Project description: Remodel an historic stone wall along the streetscape. An exception to remove historic material is requested to Sections 14-5.1 General Purpose and Relationship to General Use Zoning Districts, 14-5.2 (C,1,a,c and d) Regulation of Contributing Structures, 14-5.2 (D,1,a and b) General Design Standards for All H Districts, and 14-5.2 (D,5,a,ii and b) Design Standards for Windows, Doors, and Other Architectural Features.

Project number: 04-10100114
Case number: H-04-114
Project type: HDRB

PROJECT LOCATION (S): 511 Paseo de Peralta

DATE: June 26, 2007
TO: Historic Design Review Board Members
VIA: Reed Liming, Long-Range Planning Division Director *RL*
FROM: David Rasch, Supervising Planner in Historic Preservation *DR*

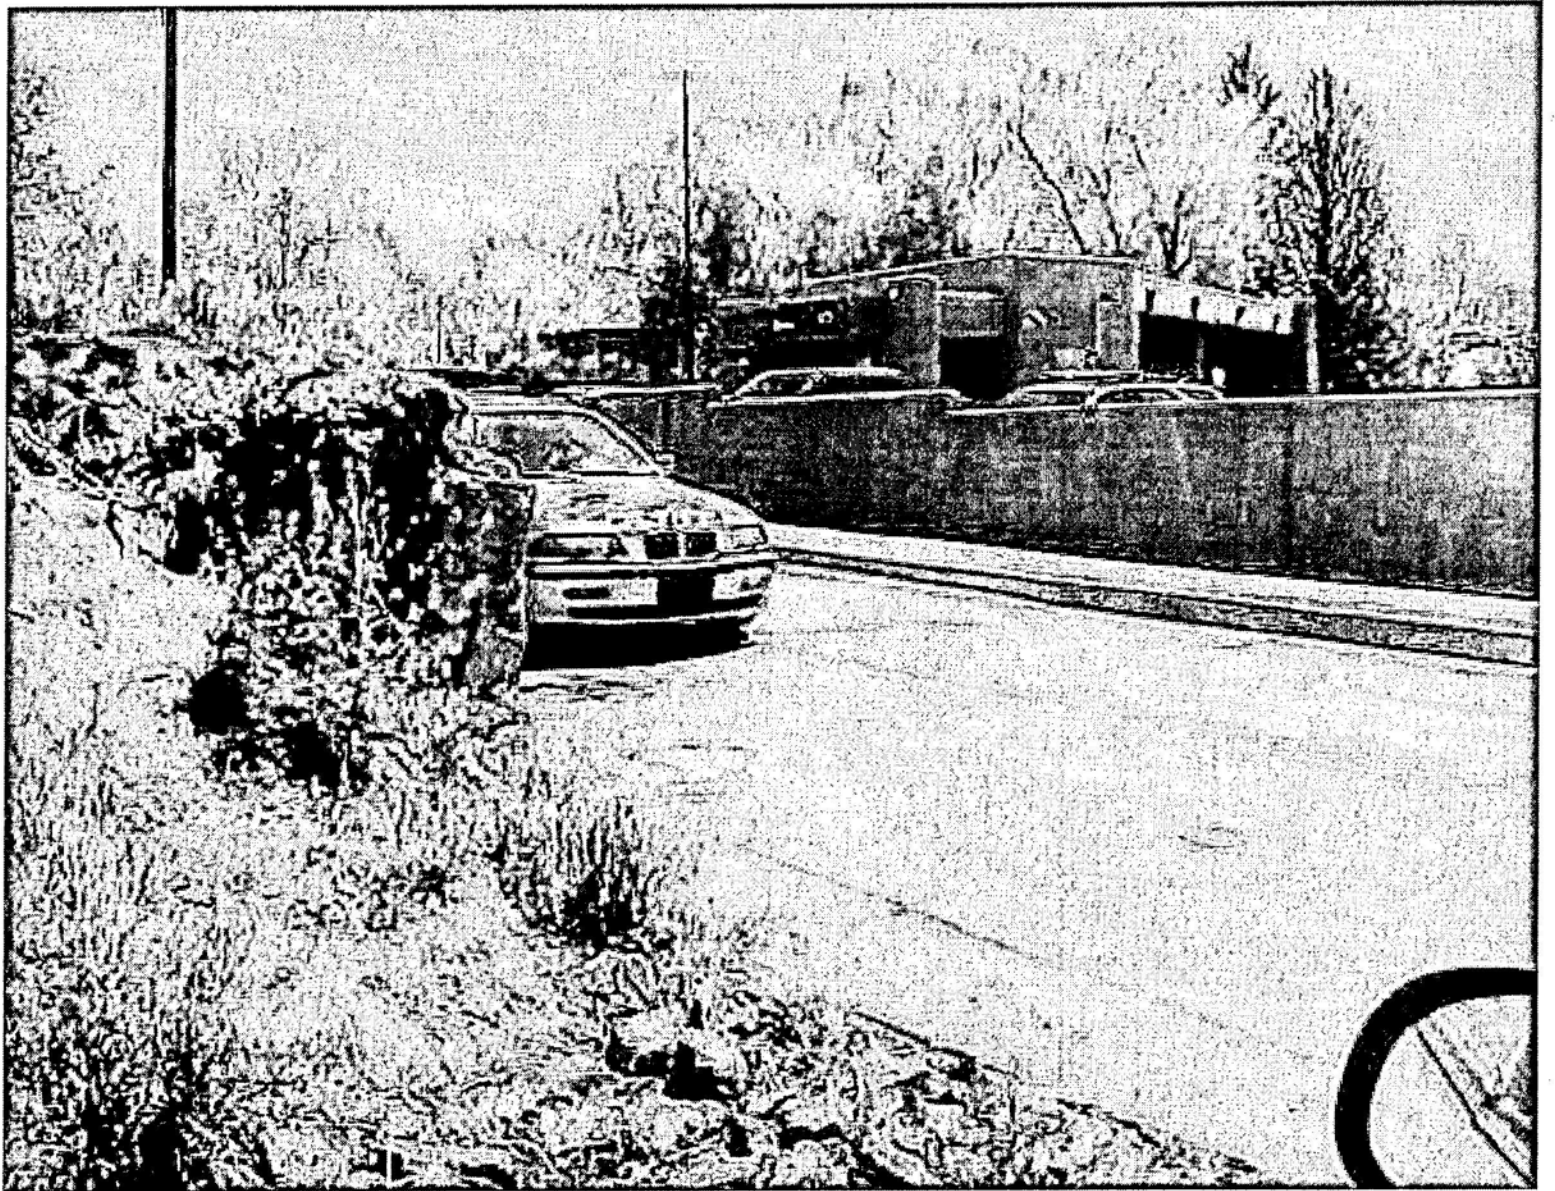
The developer has been asked by the PWD to design an access onto Paseo de Peralta with sufficient sight distance in order to accommodate a 25mph design speed (the posted speed limit on Paseo de Peralta). In order to provide adequate sight distance, the developer must remove a total of $\approx 103'$ of the wall measured from the south west corner of the subject property towards the east. This is based on requirements set forth in *A Policy on Geometric Design of Highways and Streets, 2004, 5th Edition* (Green Book), published by the American Association of State Highway and Transportation Officials. The Green Book is a nationally recognized policy used for the design of transportation facilities including urban arterials, collectors, and local roads. The guidance supplied by the Green Book is based on established practices and is supplemented by recent research.

The PWD appreciates the importance of maintaining historical features within the City of Santa Fe, where feasible, but in this case feels it important to ensure proper and safe egress and ingress from the Paseo Compound. The Transportation Research Board (who is supported by state transportation departments, the U.S. Department of Transportation, and other organizations and individuals interested in the development of transportation), through their National Cooperative Highway Research Program has made the following determination:

“Adequate sight distance for drivers at stop- or yield-controlled approaches to intersections has long been recognized as among the most important factors contributing to overall safety at unsignalized intersections. Estimates of the safety effectiveness of providing full intersection sight distance where it does not currently exist suggest that up to a 20% reduction in related crashes can be expected.”

as approved September 2005

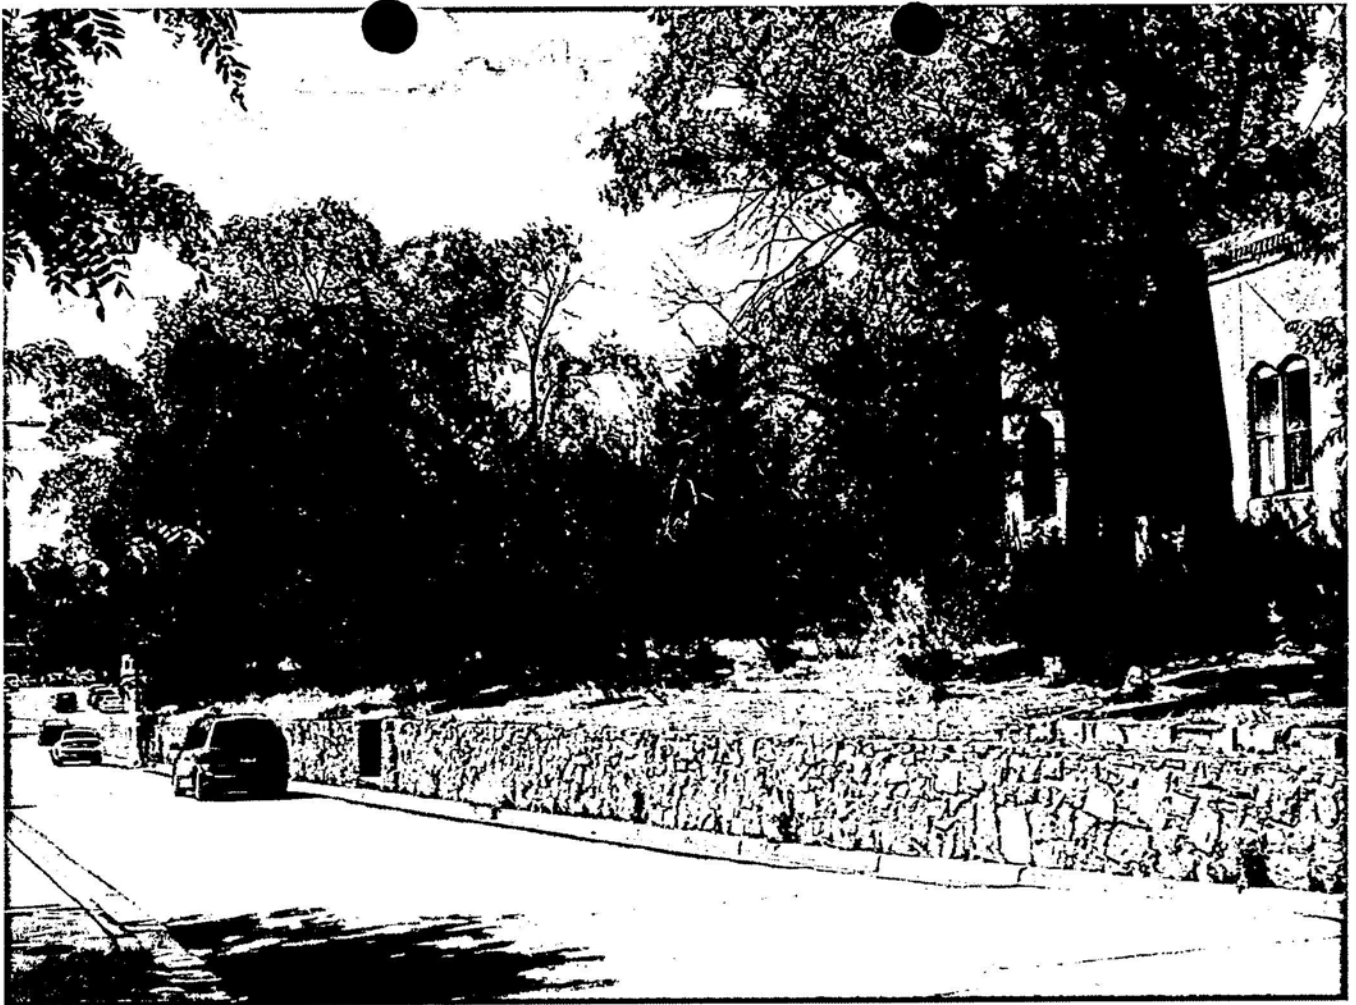
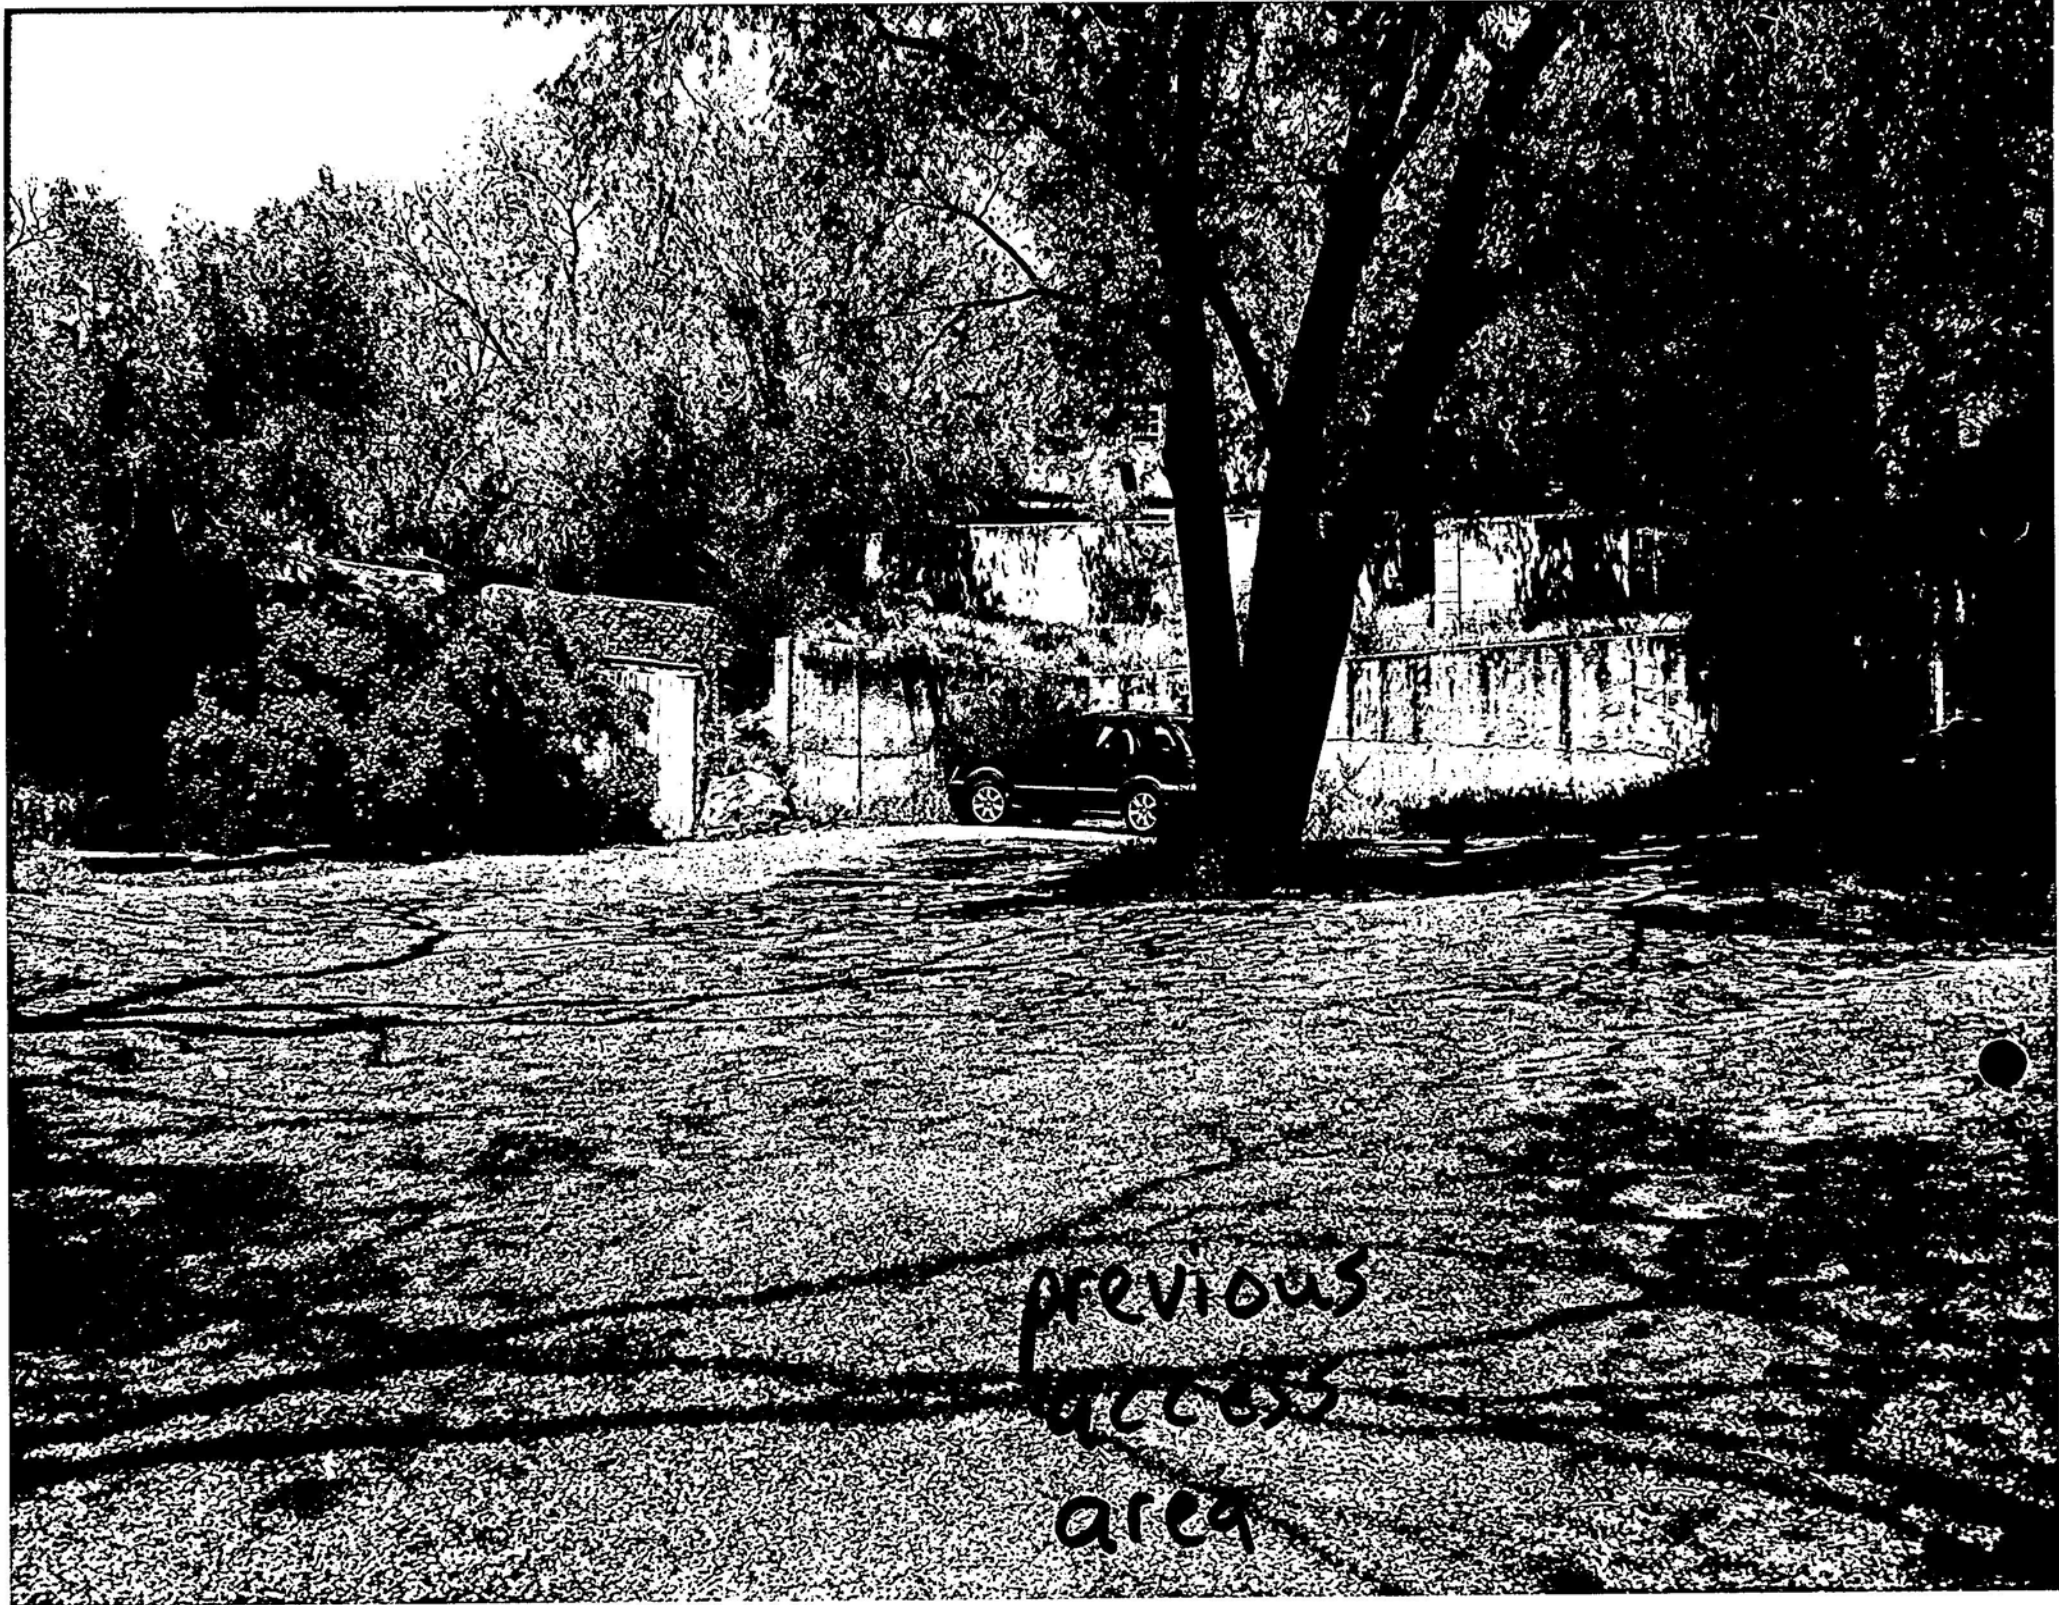
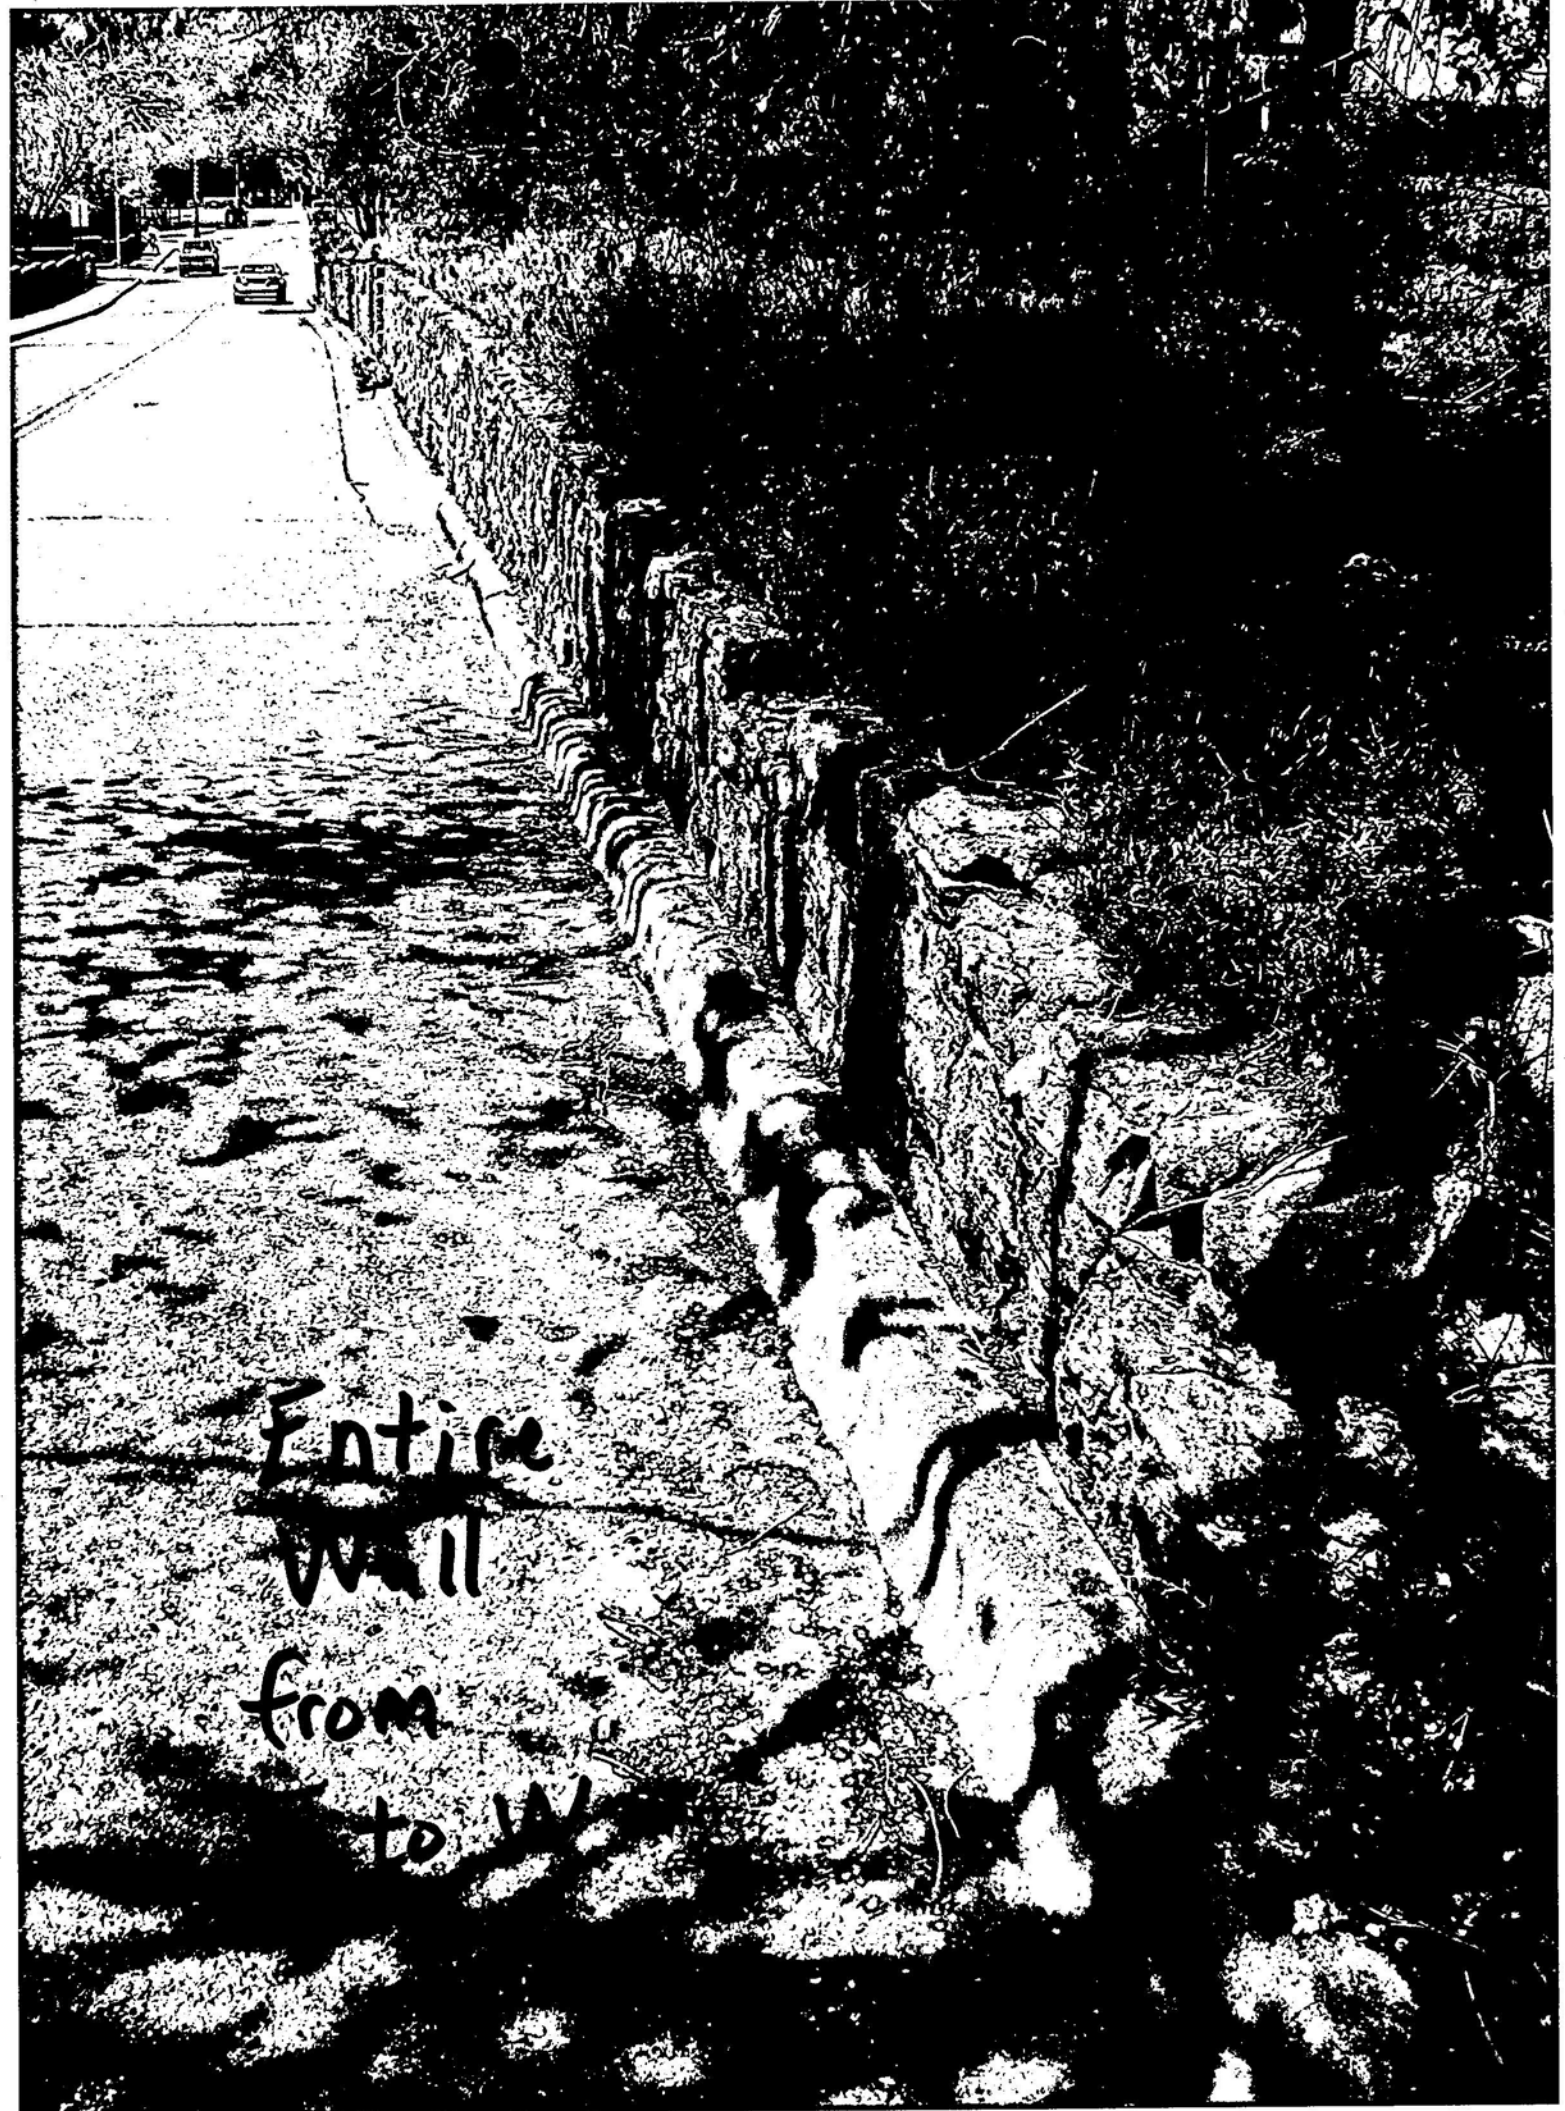
The wall as it stands does not allow sufficient sight distance to allow safe egress from the lot. There is no other ingress and egress to the lot.

There is no manner to lower the height of the existing wall. The wall is approximately 125 feet wide and 18 inches thick, making it impossible to cut through and lowered. In addition the wall could not withstand such impact and would most likely fall apart. A stucco wall is the most prudent approach as it blends into the surrounding area, and does not mimic a historic wall.
